# Tech Tips

TT 46-13-01

## Uneven Rear Brake Pad Wear 2009-2012 Routan (Vehicles Built Before 3/24/2012)

(x2) Rear Brake Carrier 7B0-615-425B

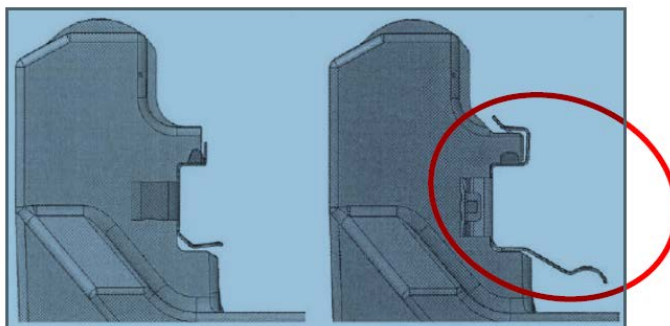
When replacing rear brake pads, it is necessary to replace both rear brake caliper adaptors.

**NOTE: There are two different sets of shims in the pad kit. The shims with the long leg (below) should be used. If installed in wrong orientation, pads will not fit properly. If the pads have a protective paper on the rear face of the brake plate, it must be removed before pad installation.**

**New Clip Part number 7B0698269A**
